ADDENDUM NO. 3

Reference: New Classroom Building
UVU - Orem, Utah
DFCM Project No. 12192790

ADDENDUM NO. 3
May 22nd, 2013

Utah Valley University Classroom Building
Orem, Utah

Level 1 Area 'B' Floor Plan (A5 / AE101B)
1/8" = 1'-0"

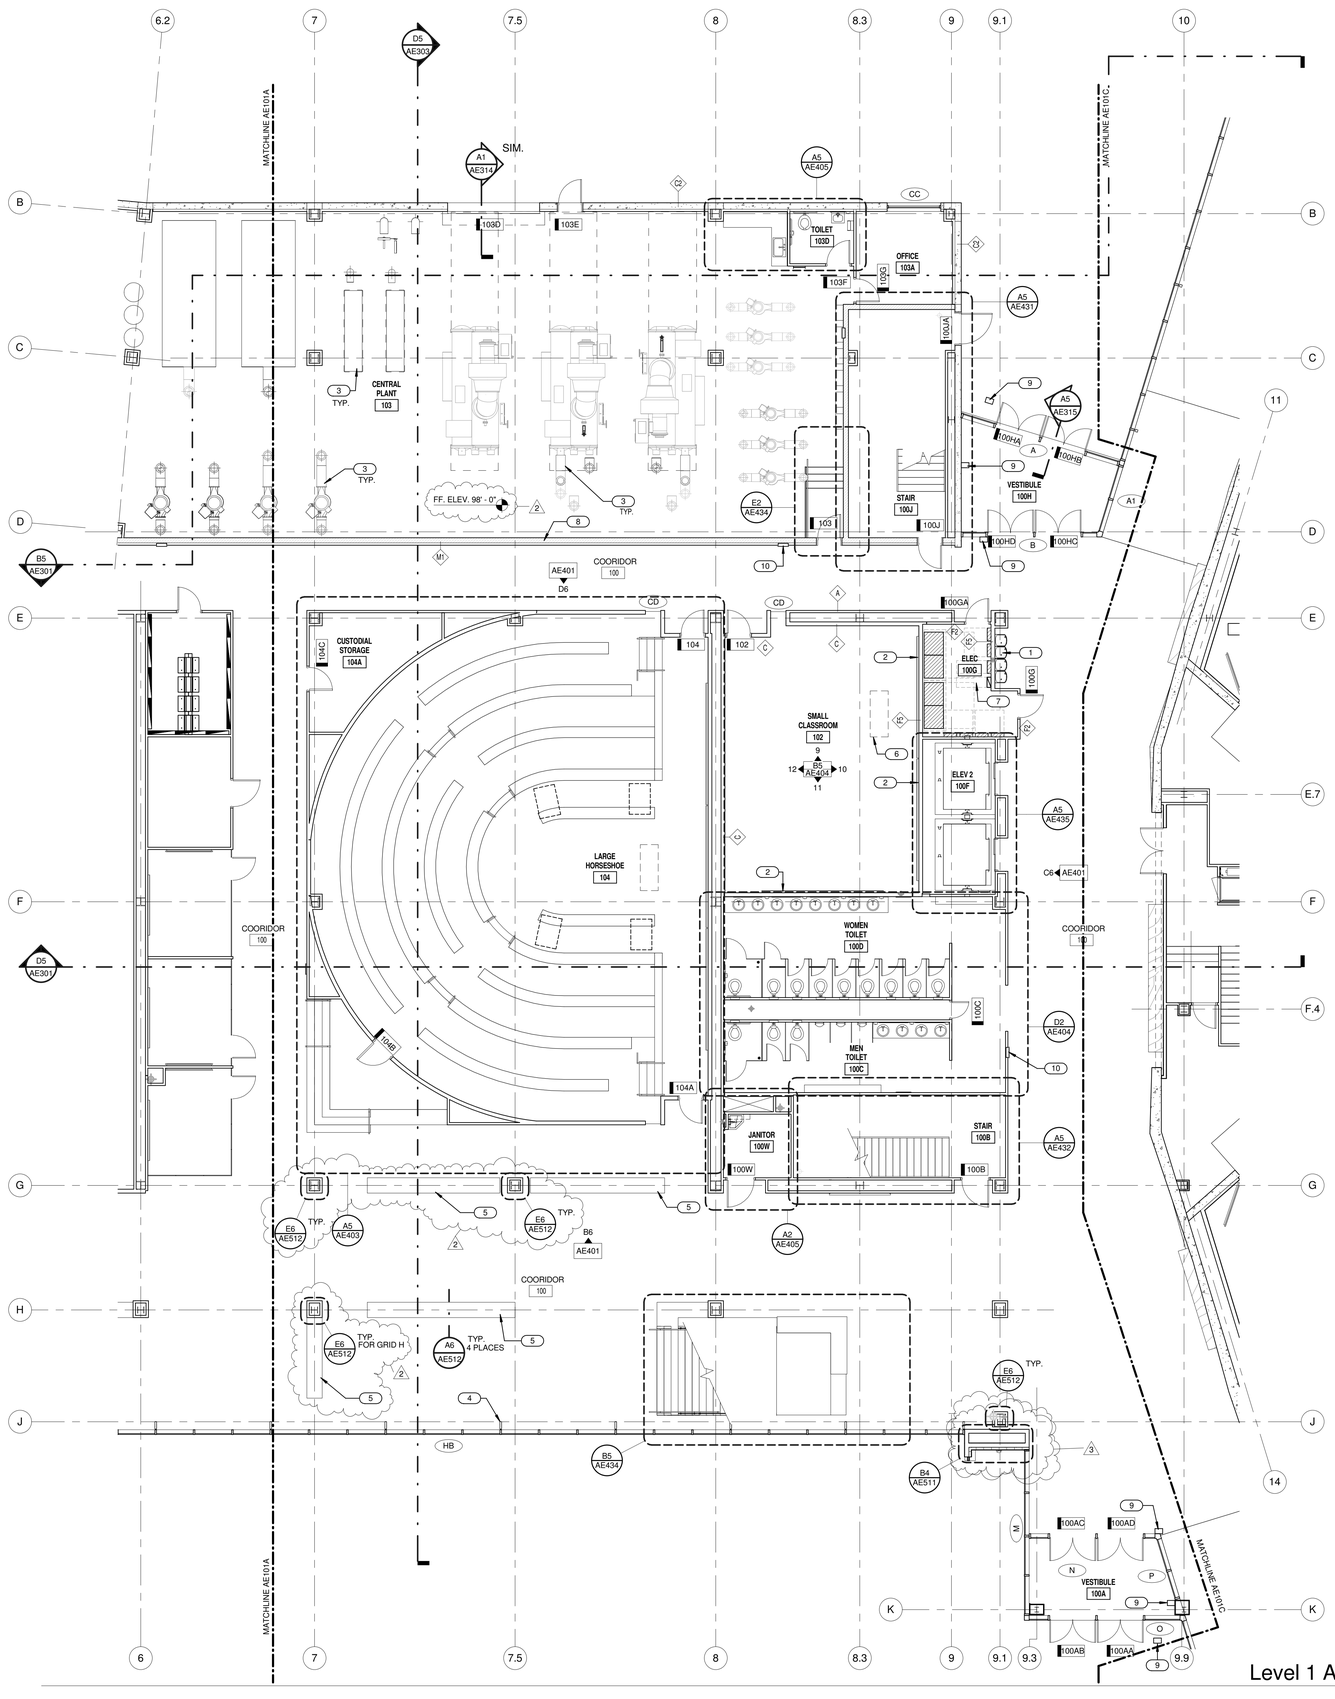
4. Sheet AE101B, added detail reference for enlarged plan at grid intersection J & 9.1.
5. Sheet AE105B, modified curtain wall BD along grid line 10 and south of grid line F.4, incorrect width shown.

Level 6 Area 'B' Penthouse Floor Plan (A5 / AE106)

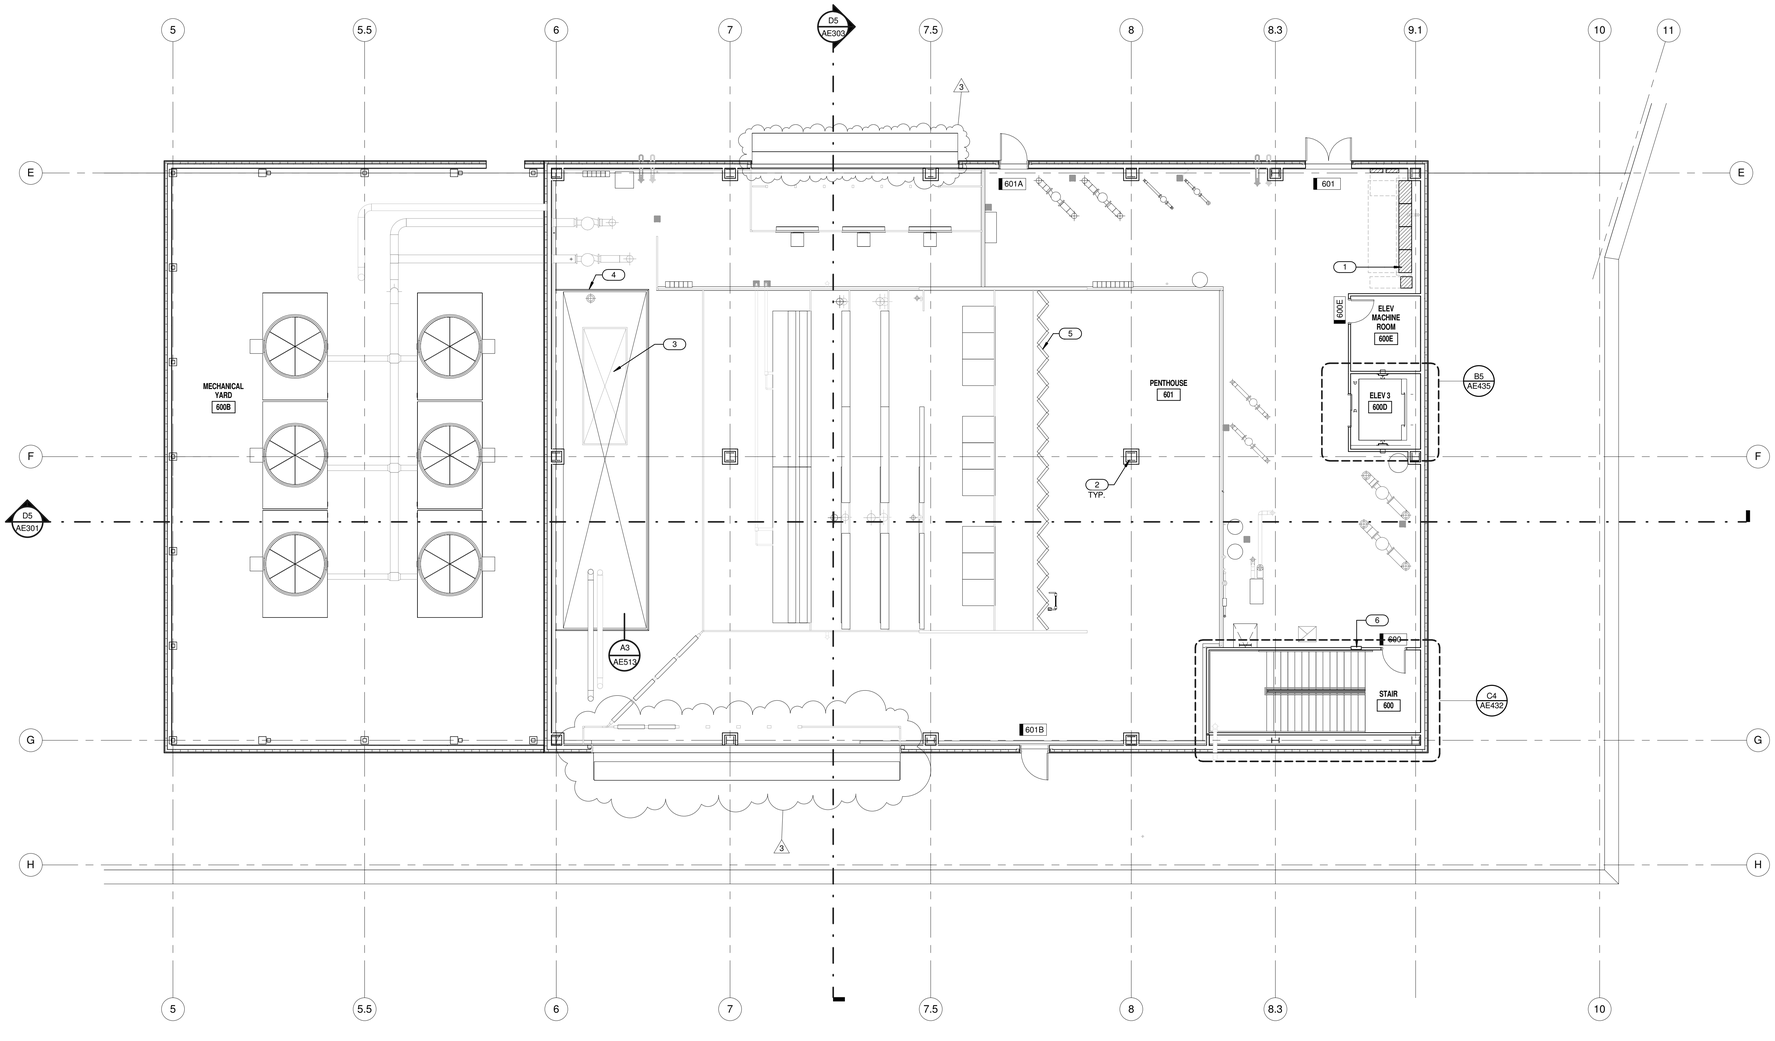
6. Sheet AE106, modified size of storm louvers on grid line E and G to match mechanical, Modified location to match mechanical plans.
7. Sheet D5AE201, size of louver modified to match mechanical louver size as scheduled

Level 1 Area 'A' Finish Plan (A5 / AE111A)

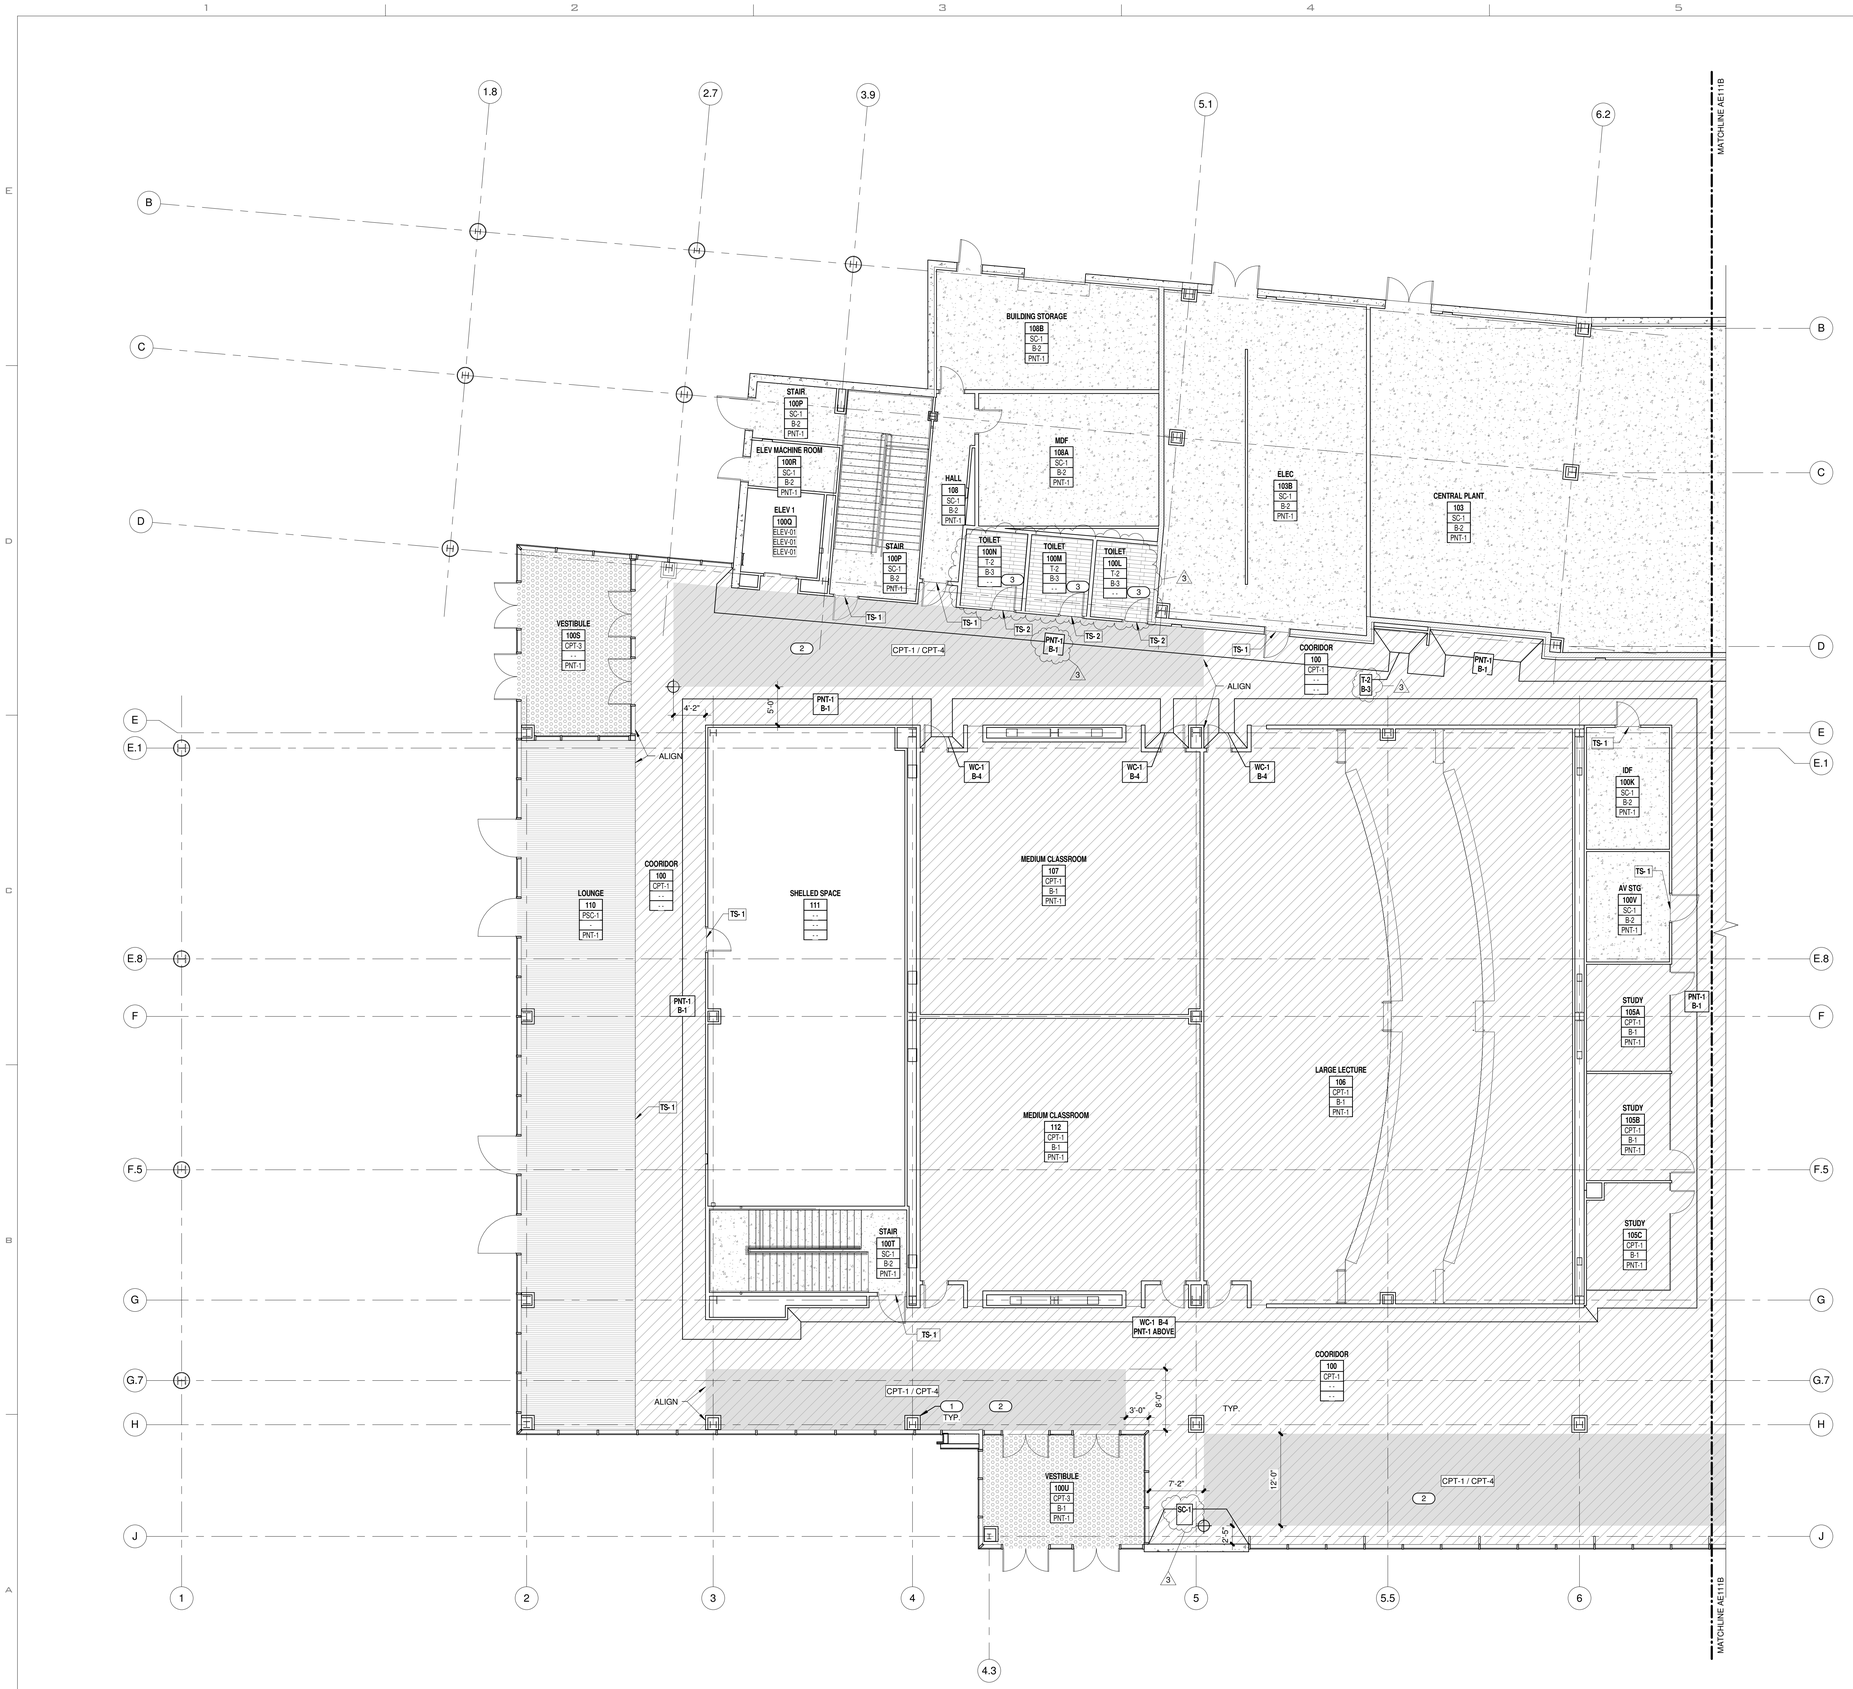
9. Sheet AE511, revised note on detail C3 & B4/AE511 to read "EXTERIOR COMPOSITE WOOD PANEL SYSTEM".
10. Sheet AE111A, revised floor finish of Toilet Rooms 100L, 100M, 100N. Revised wall finish at concrete wall at grid line intersection J & 5. Added base to wall & base specific tag for wall and base finish.

Level 1 Area 'B' Finish Plan (A5 / AE111B)

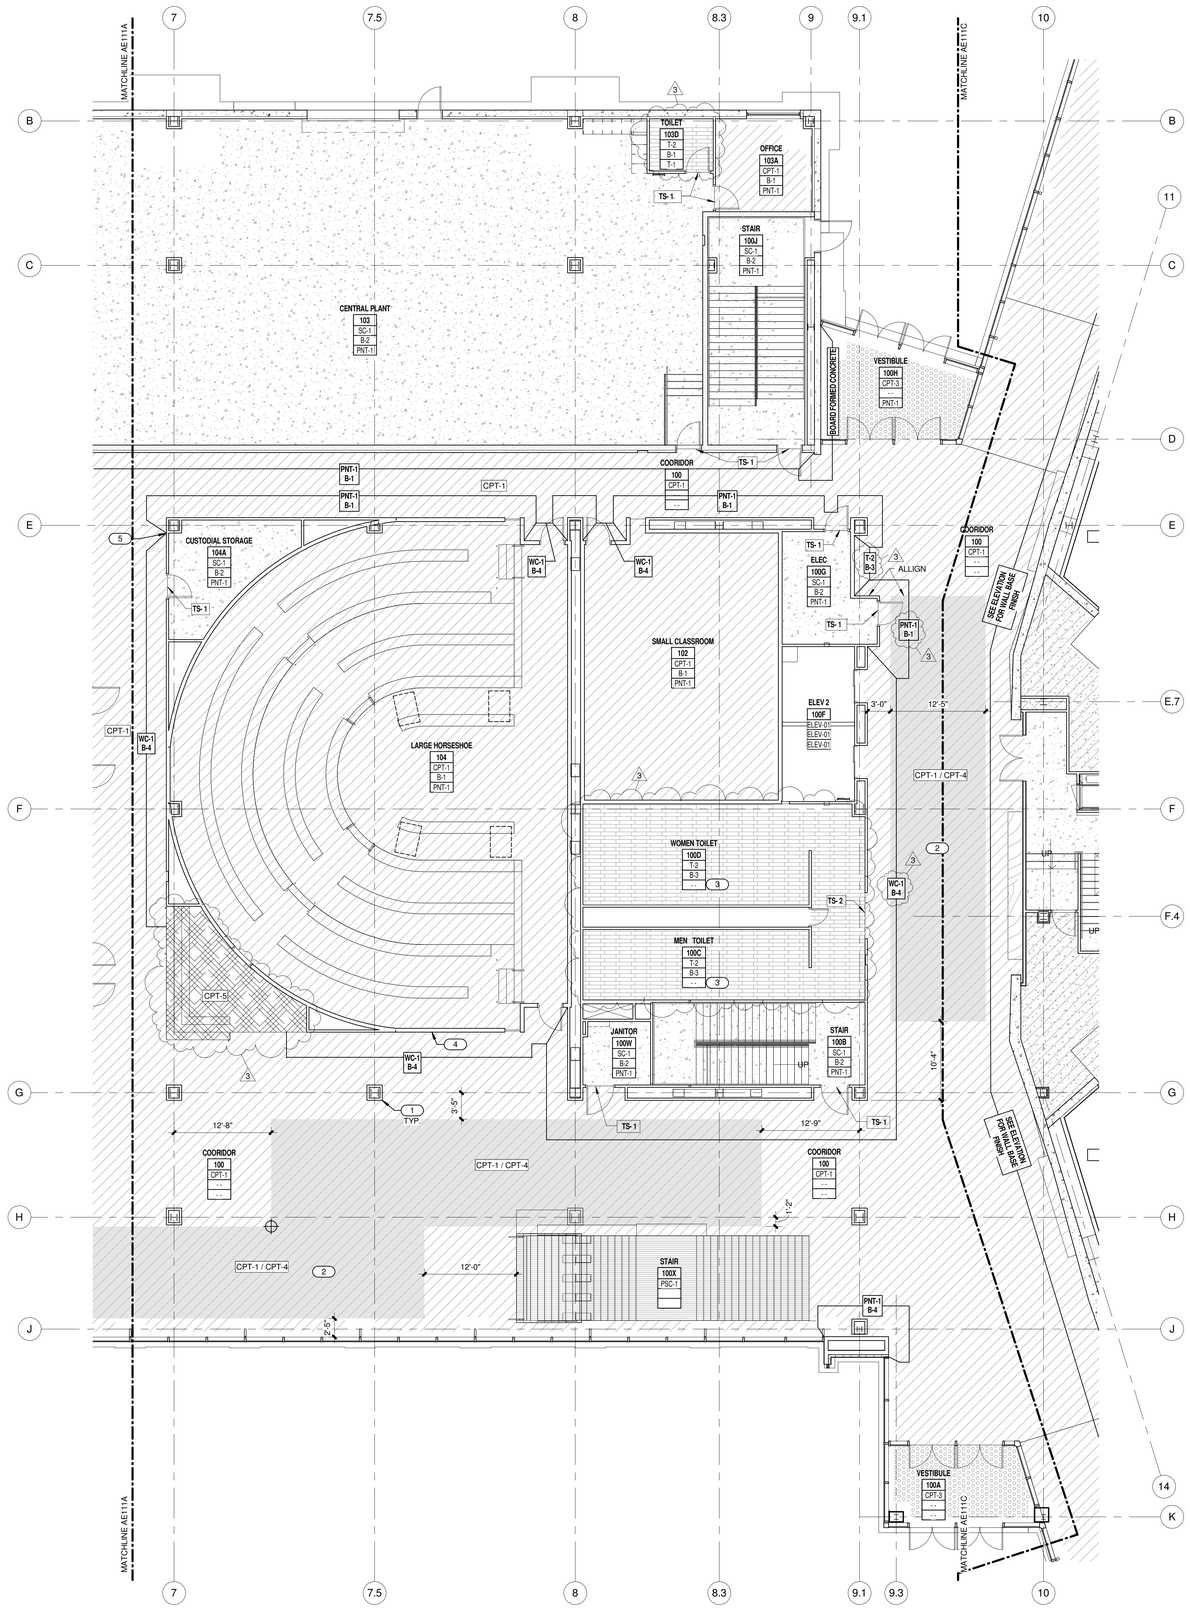
11. Sheet AE111B, revised floor finish at southwest stepped entry to Horseshoe 10A, revised finishes of Toilet 103D. Revised finishes of the main Women's and Men's restrooms. Revised finishes in east corridor of area B.
